**City of Ramsey**  
**Agenda**  
**Public Works Committee**  
**Tuesday January 17, 2012**  
**3:30 pm**  
**Lake Itasca Room, 7550 Sunwood Drive NW**

Consider lighting retrofit for parking ramp project

Ramsey Municipal Parking Ramp Phase II  
 City Project # 10-22  
 Change Order Request

Consider Guard Rail Enhancements for the Parking Ramp

1  
3A PARAPET GUARDRAIL - TYPICAL BAY

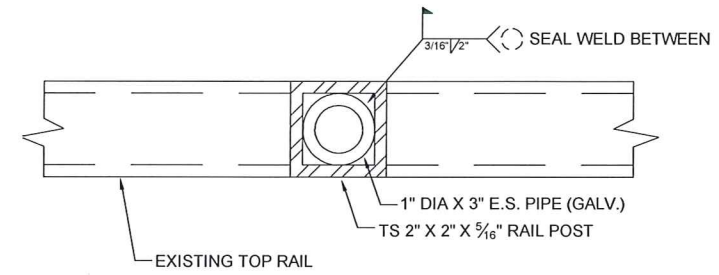
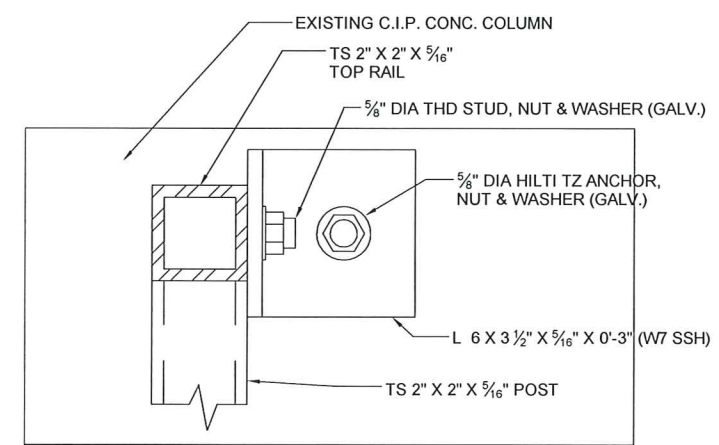
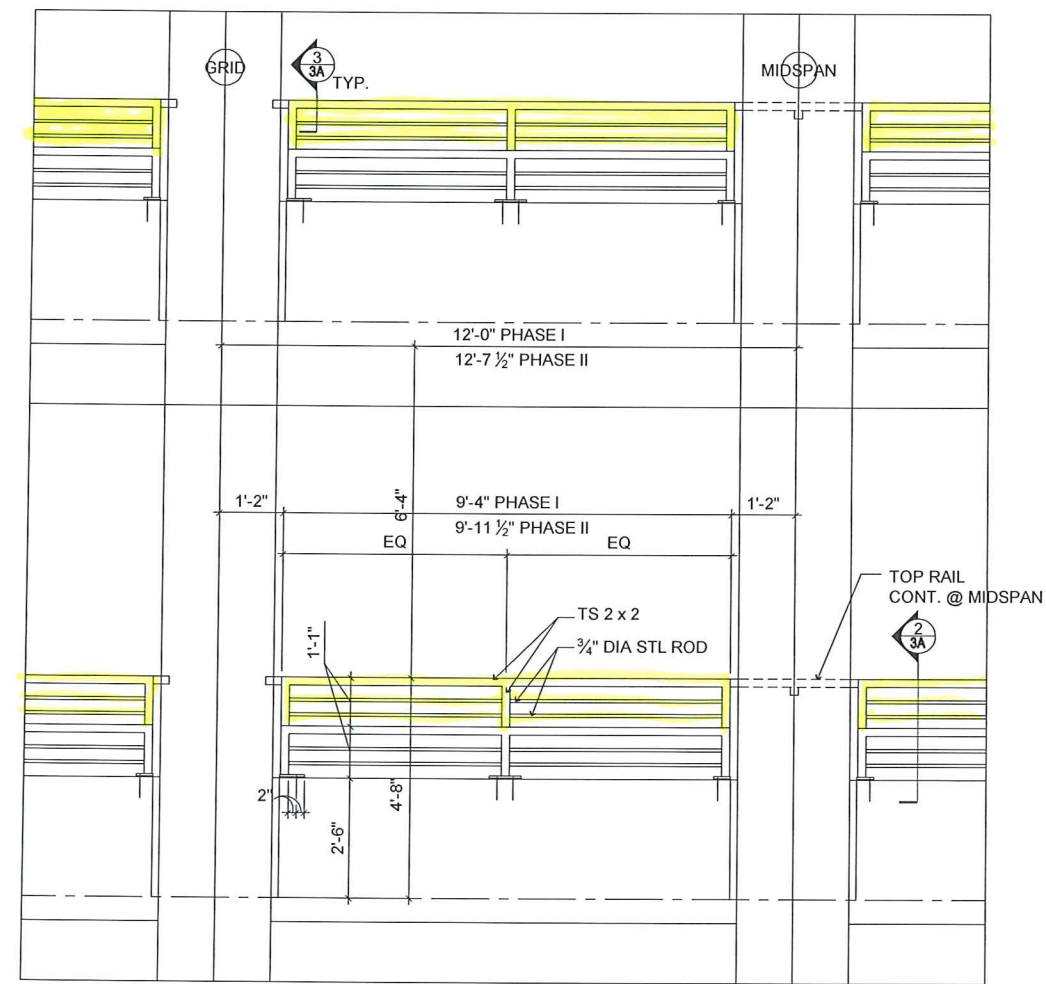
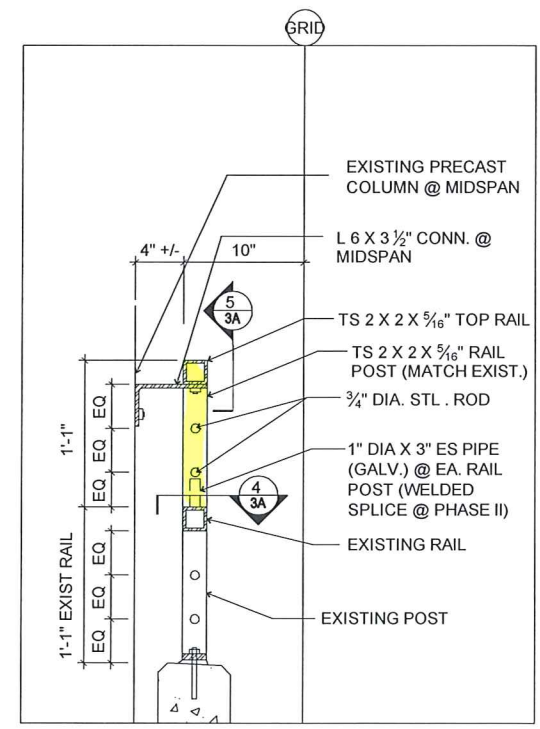
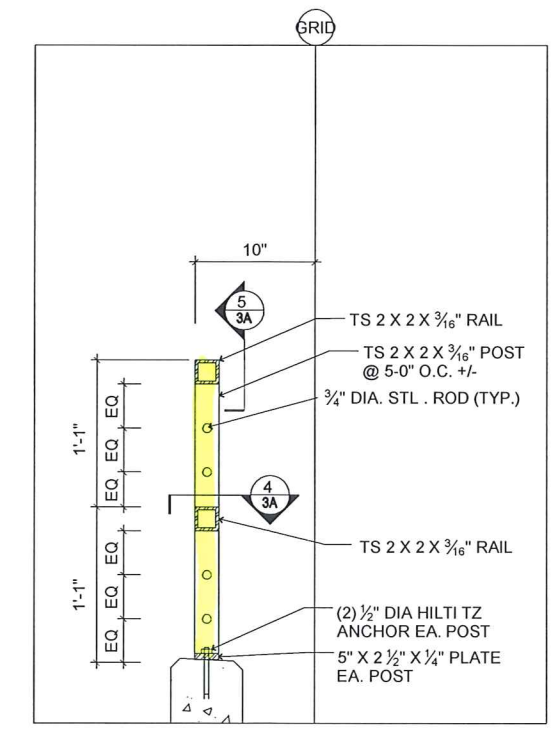
Revise the metal guardrail/screen details for the parking facility as noted on the attached drawing for Option A or Option B, or a combination of the two Options. Provide a breakdown of the pricing as follows:
